STATE BUILDING CODE INTERPRETATION NO. I-06-09

July 27, 2009

The following is being offered in response to your letter in which you seek a formal interpretation. The question applies to exit enclosure penetrations addressed in Section 1019.1.2, of the 2003 International Building Code portion of the 2005 State Building Code.

4 HANGER DETAIL SCALE: 1 1/2" = 1'-0"

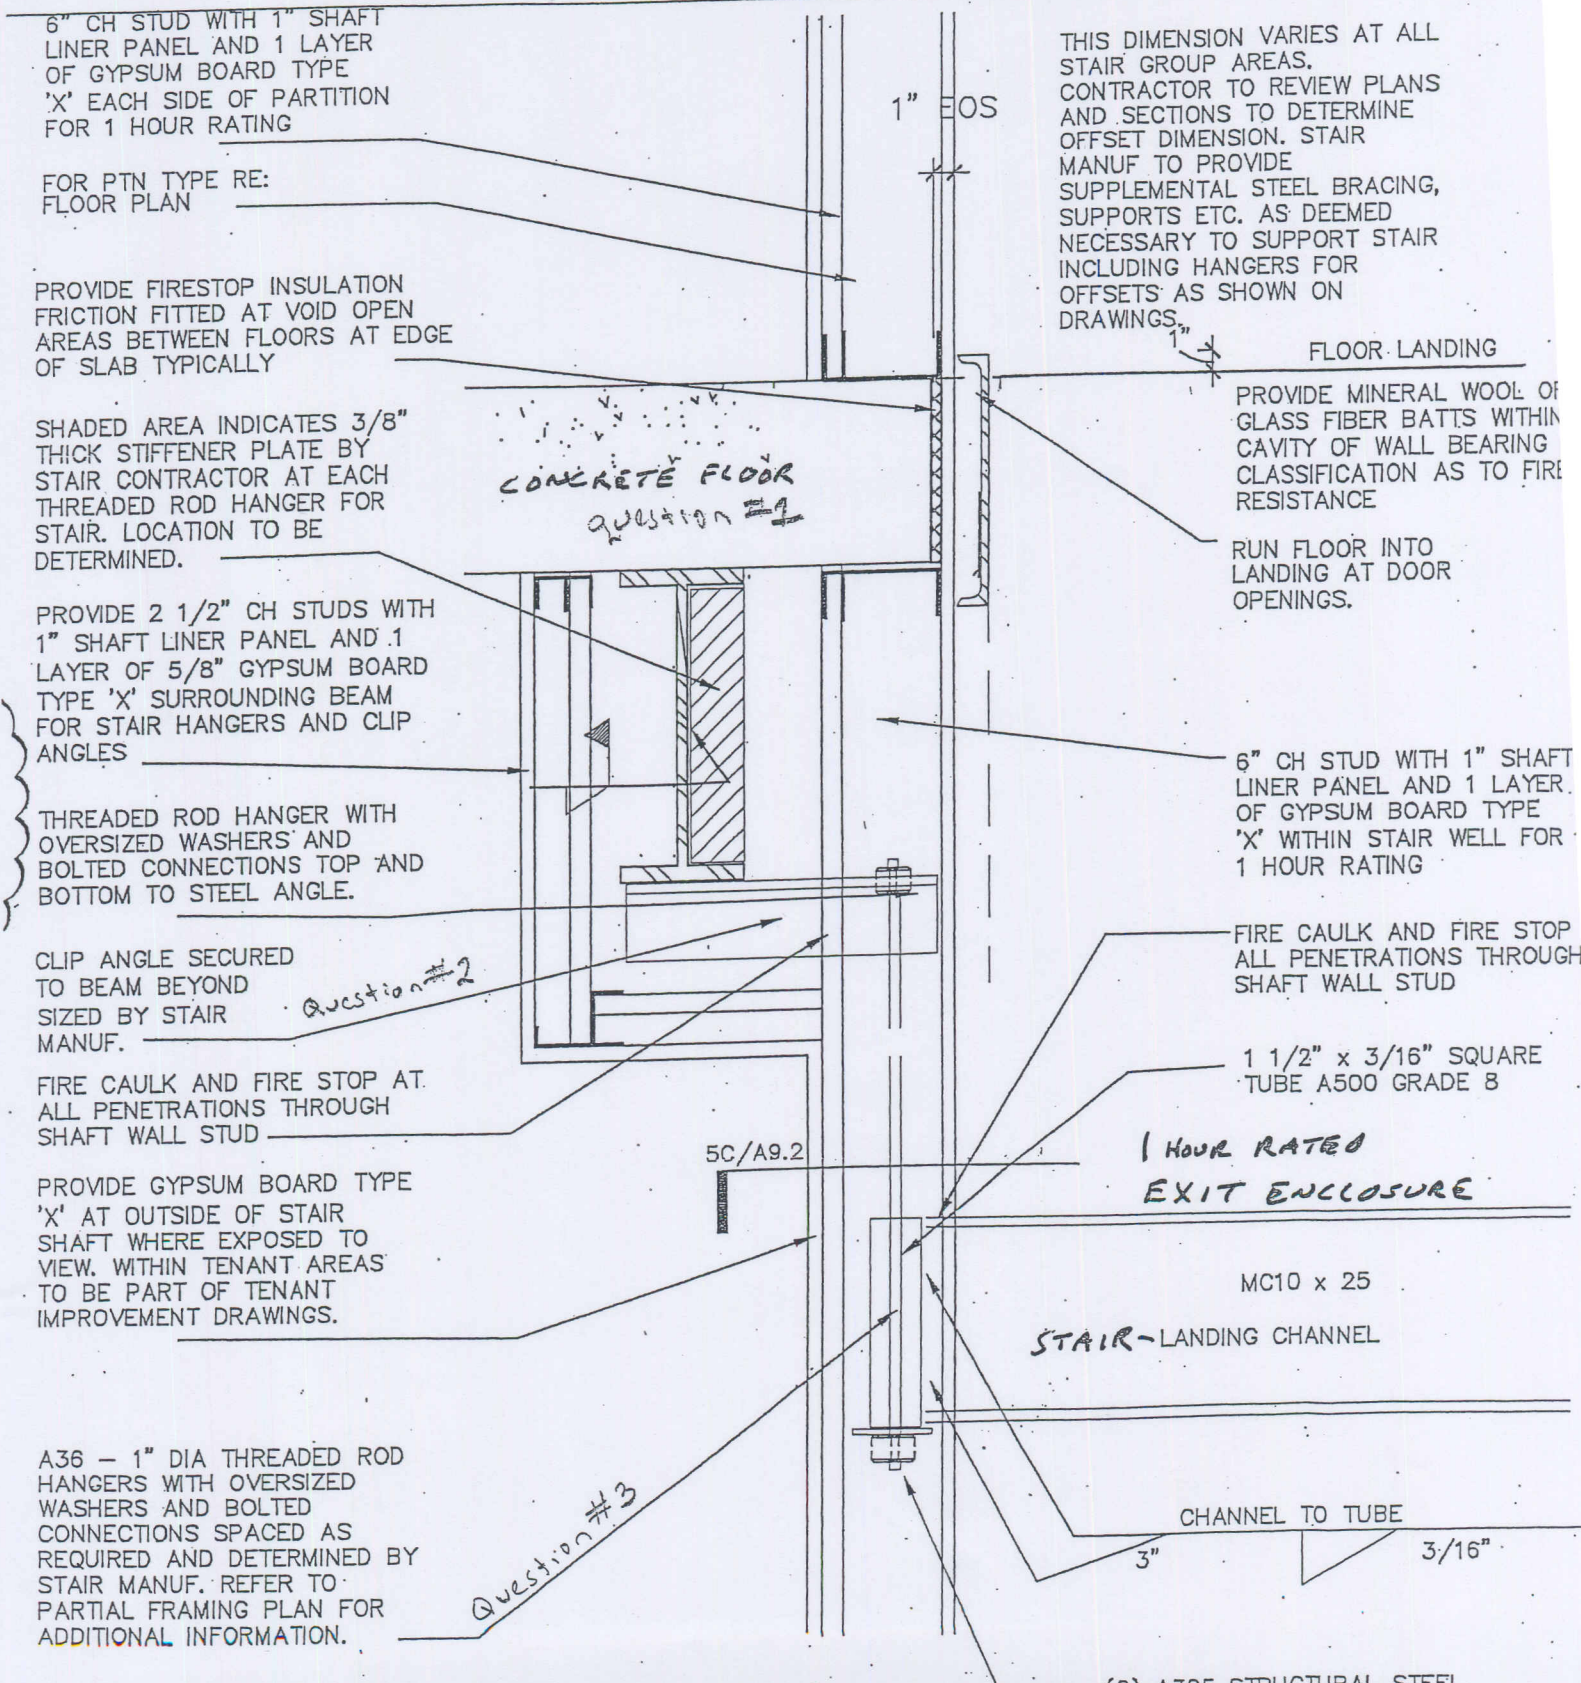
The concrete slab of the second floor penetrates the exterior membrane of the proposed fire separation of the vertical exit enclosure. Is this noncombustible single membrane penetration allowed if the concrete floor supports the rated enclosure?

A welded steel clip that supports the interior stairs and landings penetrates both membranes of the vertical exit enclosure. Is this penetration allowed? (Stair section diagram included.)

If the penetration of the clip is allowed, will all the steel supporting the clip and landing etc., need to be protected to the foundation as is required for the supporting construction of rated assemblies in the IBC-2003, Section 706.4? (Stair section diagram included.)

This noncombustible single membrane penetration would be acceptable only when the concrete floor and all its supporting construction is a listed fire rated assembly (having the same minimum code required hourly fire rating as the fire rated wall it is supporting). Section 721 of the 2003 International Building Code portion of the 2005 State Building Code provides information to establish a fire resistance rating if there is existing concrete floor. Supportive information documenting fire rating code compliance needs to be provided in the permit documents.

The diagram submitted is not code compliant due to the limited descriptive information given which does not address the relative components fire rating.

The only penetrations allowed in an exit enclosure are addressed in Section 1019.1.2 of the 2003 International Building Code portion of the 2005 State Building Code. However, the diagram submitted illustrates a fire rated shaft wall encasing the stair support clip that penetrates the stair enclosure membrane, (this faces outside the stairway). This detail would be acceptable provided the shaft wall assembly and penetration are listed fire rated assemblies.

Product manufacturers of shaft wall system brochures typically provide details addressing stair hanger rod membrane penetrations and fire rated listed assemblies information that may be helpful.

The penetration of the welded steel clip that supports the stair construction is acceptable when the wall assembly and penetration are listed fire rated assemblies. Continuity of the vertical exit enclosure's fire rated construction and its supporting construction is required.

The diagram submitted is not code compliant due to the limited descriptive information given which does not address the relative components fire rating.
